GILA RIVER WATERSHED ENVIRONMENTAL REVIEW COMMITTEE MEETING PACKET

MEMO TO: GILA RIVER WATERSHED ENVIRONMENTAL REVIEW COMMITTEE
FROM: RANDY HEISS, EXECUTIVE DIRECTOR
DATE: DECEMBER 12, 2016
SUBJECT: DECEMBER 14, 2016 CONFERENCE CALL AGENDA

PROJECT DESCRIPTION/ANALYSIS
MORENCI WASTEWATER TREATMENT PLANT PROJECT
Revised December 1, 2016

EXHIBIT B

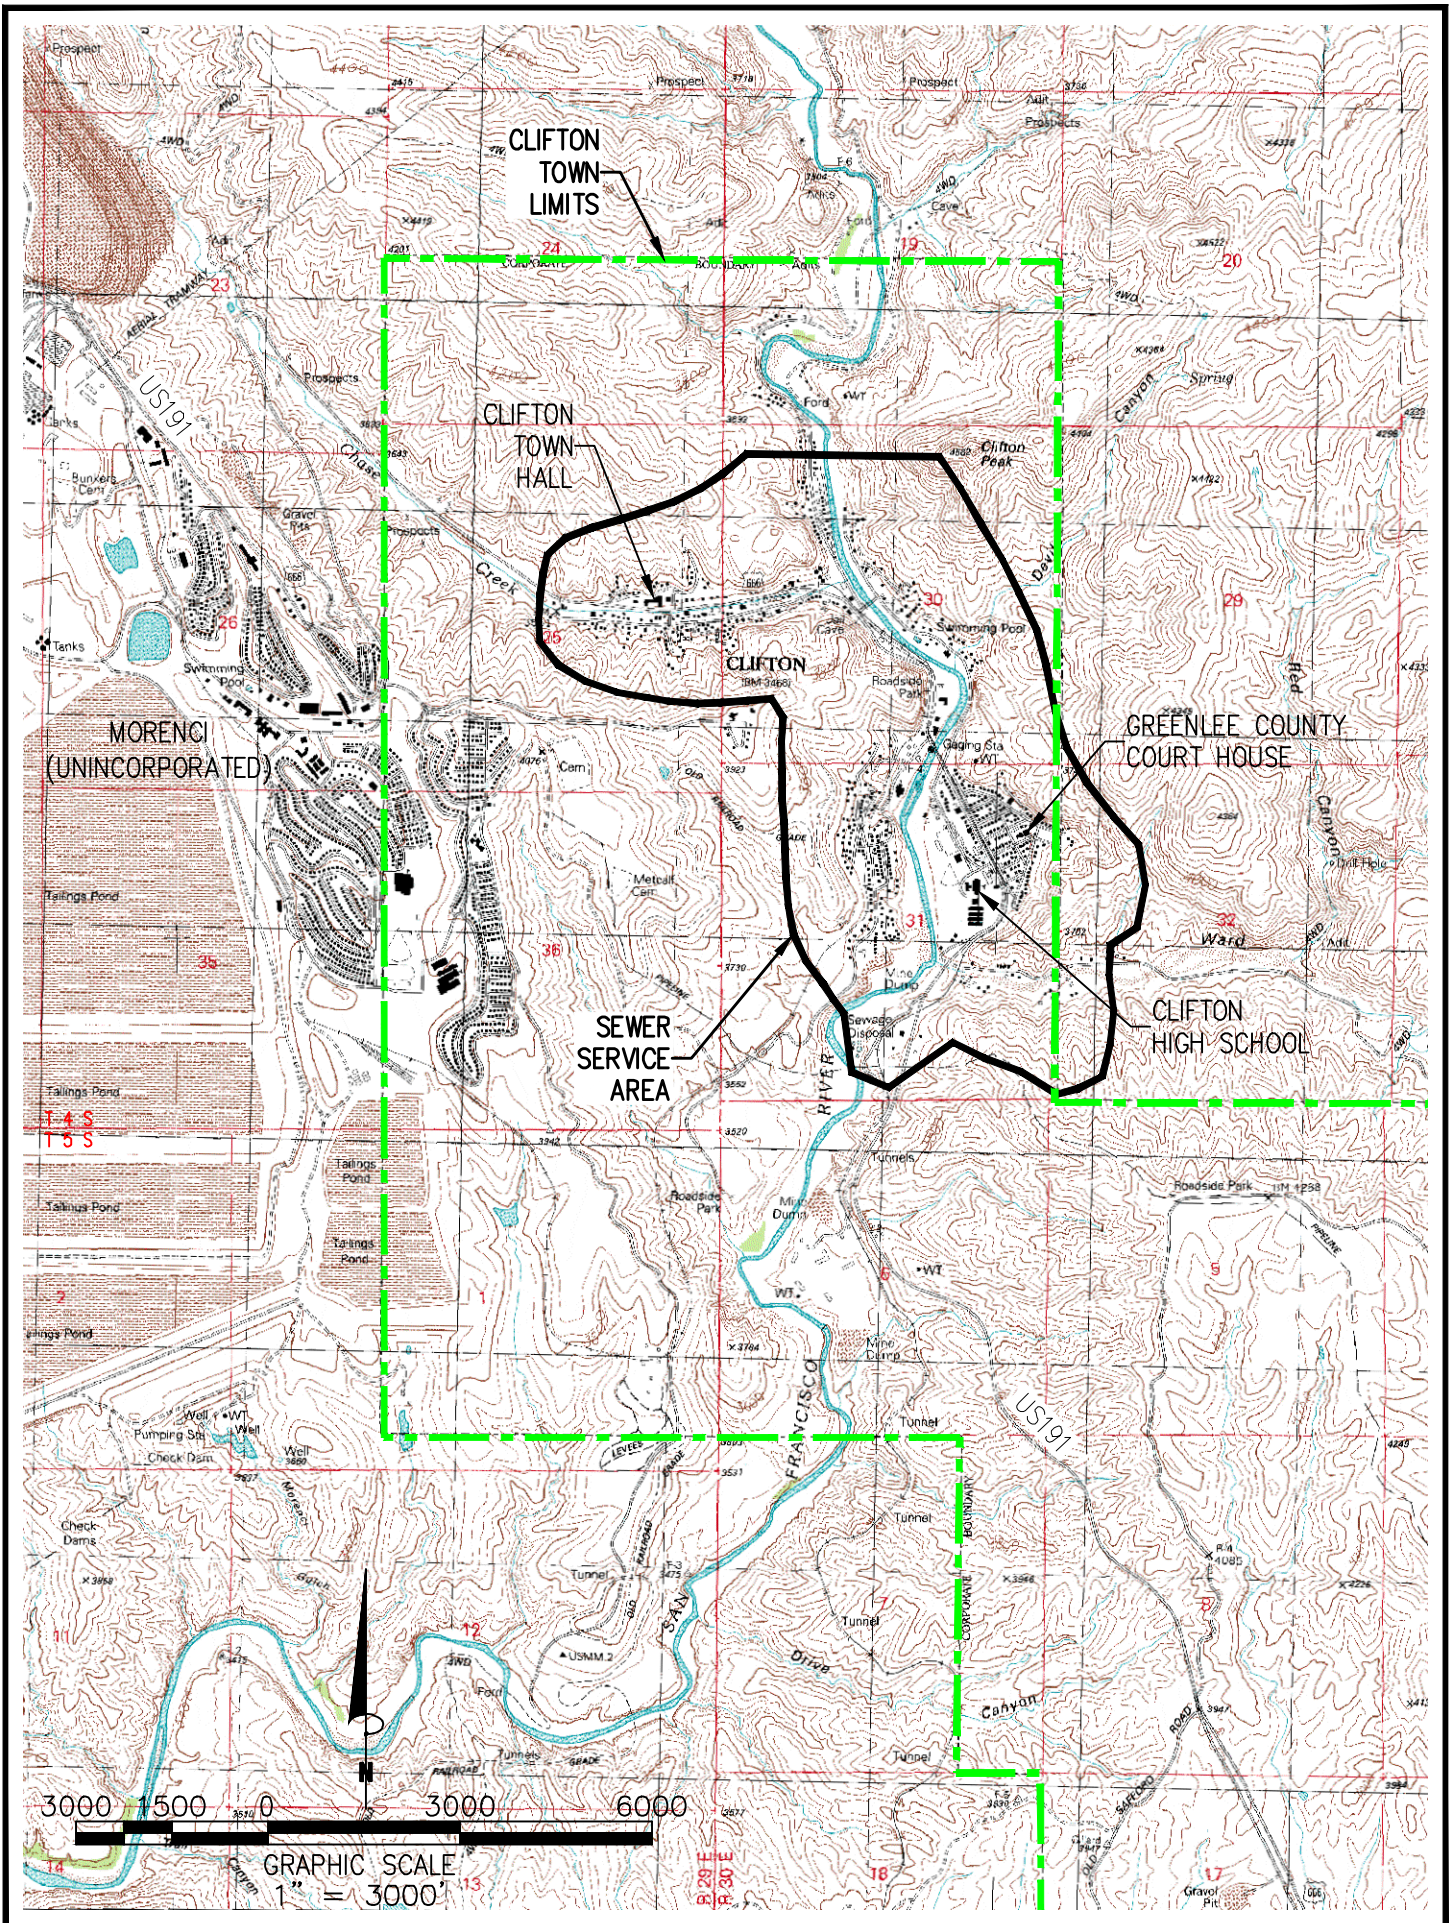
A map showing the Town of Clifton service area is attached to this report as Exhibit B. The 'service area' appears to include the most densely populated areas inside the corporate limits of the Town, and a small area outside of the Town limits. Most areas inside the corporate limits of the Town are not connected to the sewer system. Most notably, the sections south and east of Ward Canyon owned by the State of Arizona and US Bureau of Land Management remain mostly undeveloped. If these areas are developed in the future, it is likely developers will be required to determine the feasibility of connecting to the Clifton WWTP. If feasible, development would likely be required to pay for any costs associated with connecting to the existing system and additional capacity requirements at the WWTP, build separate satellite wastewater treatment facilities, or develop the land with larger lot sizes that can accommodate on-site systems.

EXHIBIT E

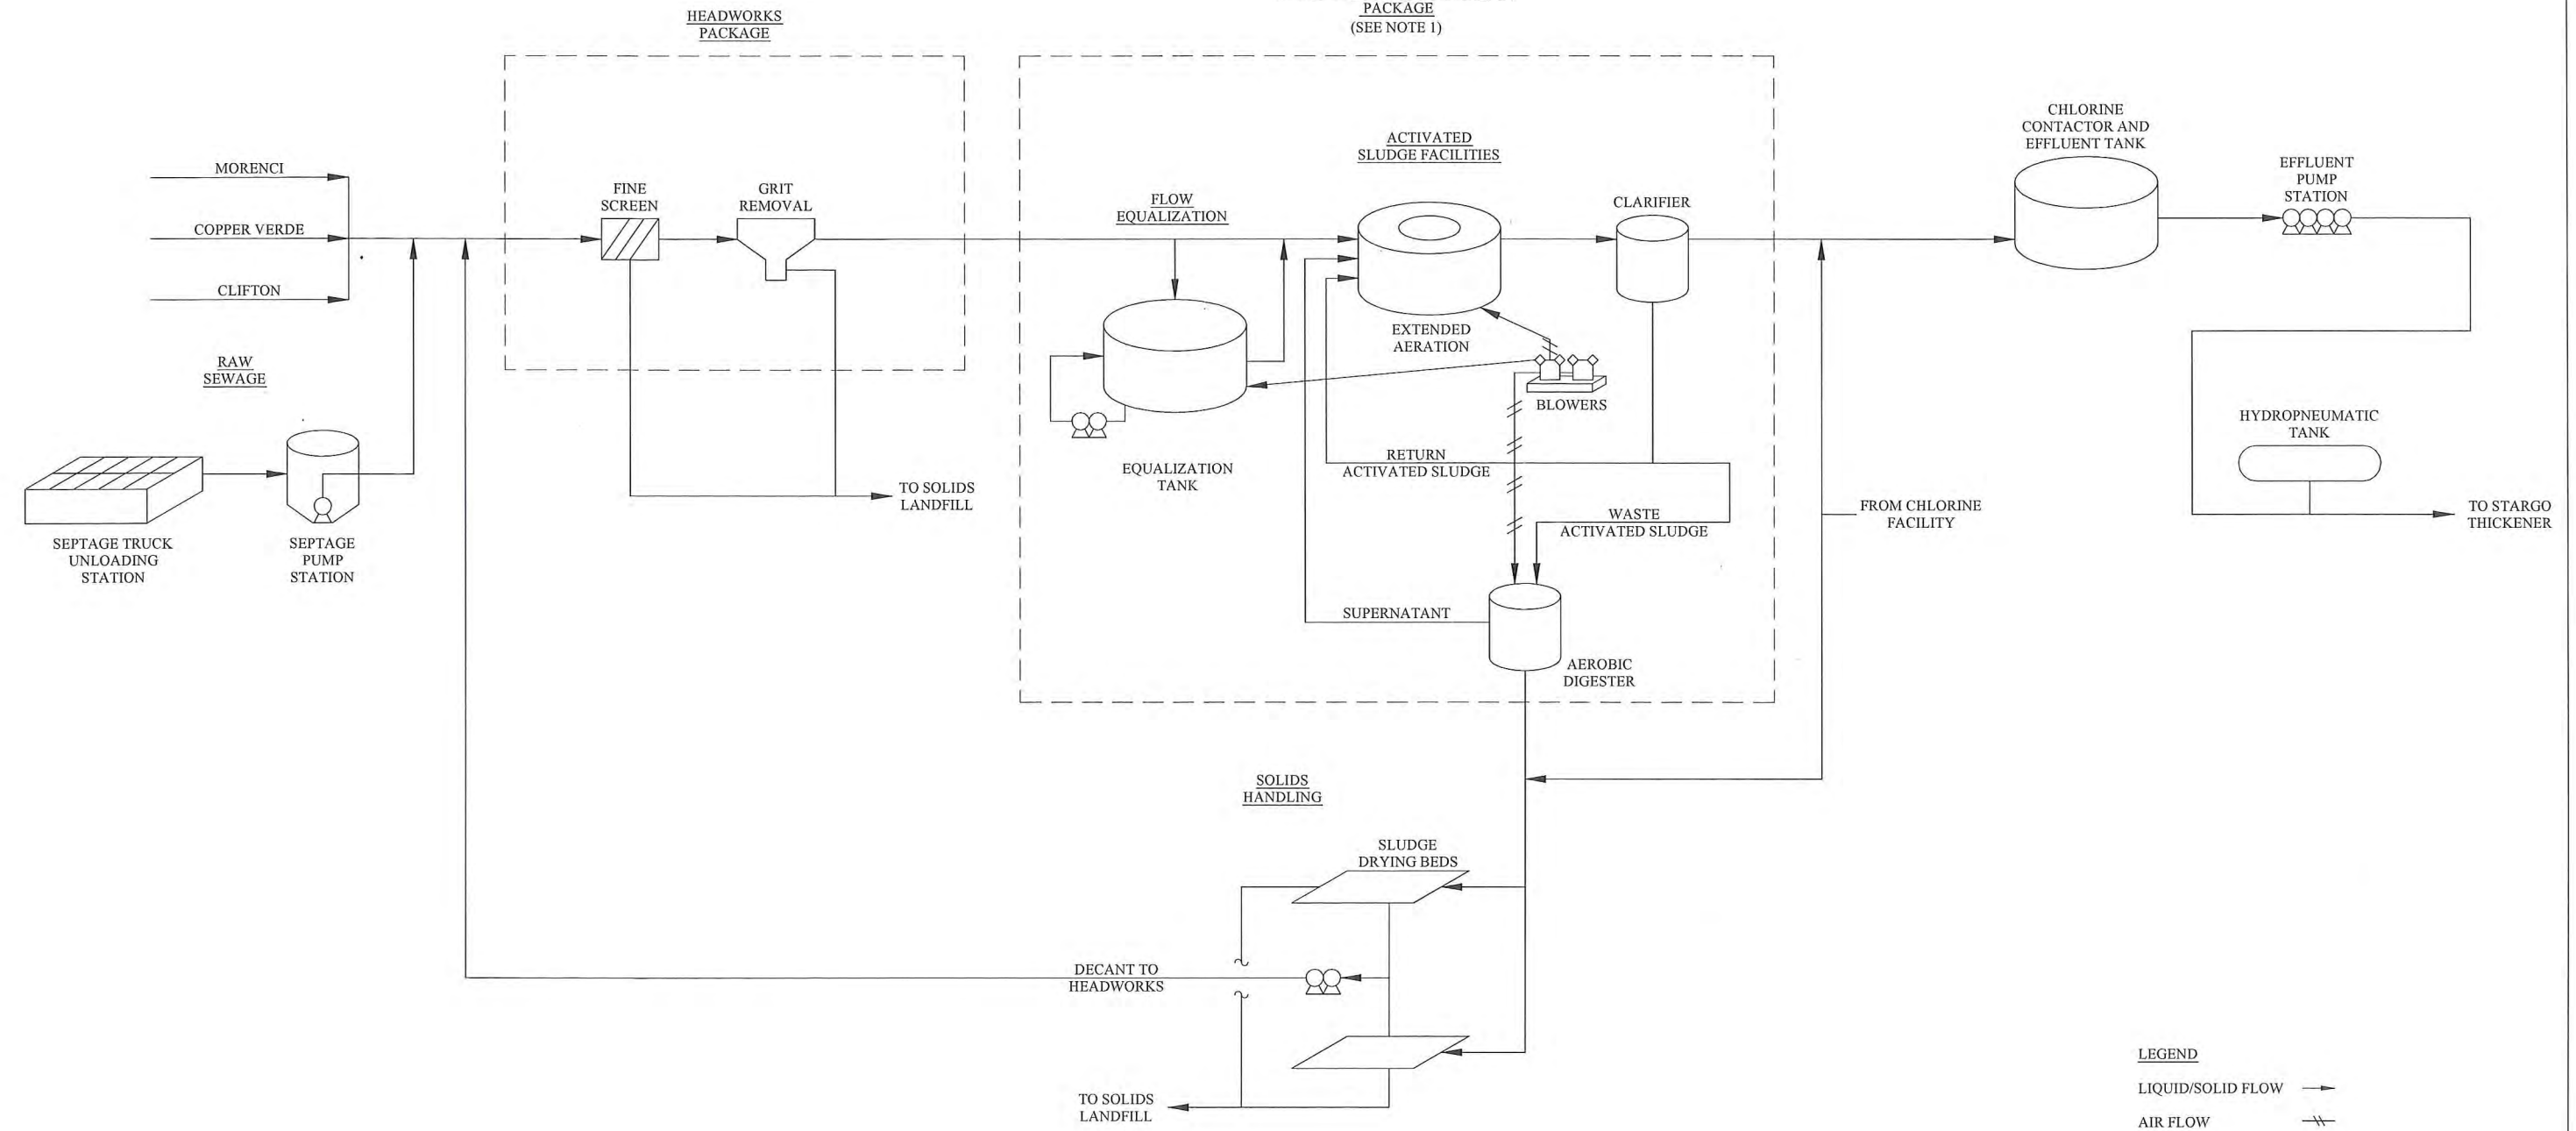
Wastewater will enter the headworks and flow into a fine and grit screen before entering an activated sludge tank. To handle periods of high flows, an equalization tank will be placed in line ahead of the activated sludge tank. The wastewater then moves to a clarifier where it will drop more solids. Biosolids flow into an aerobic digester and then are placed in concrete drying beds where excess liquids will be removed and returned to the headworks. Prior to sending the effluent to the reclaimed water system and/or tailings, the water is treated with chlorine tablets in a contact chamber. Exhibit E provides a flow diagram of the wastewater treatment process for the proposed Morenci WWTP.
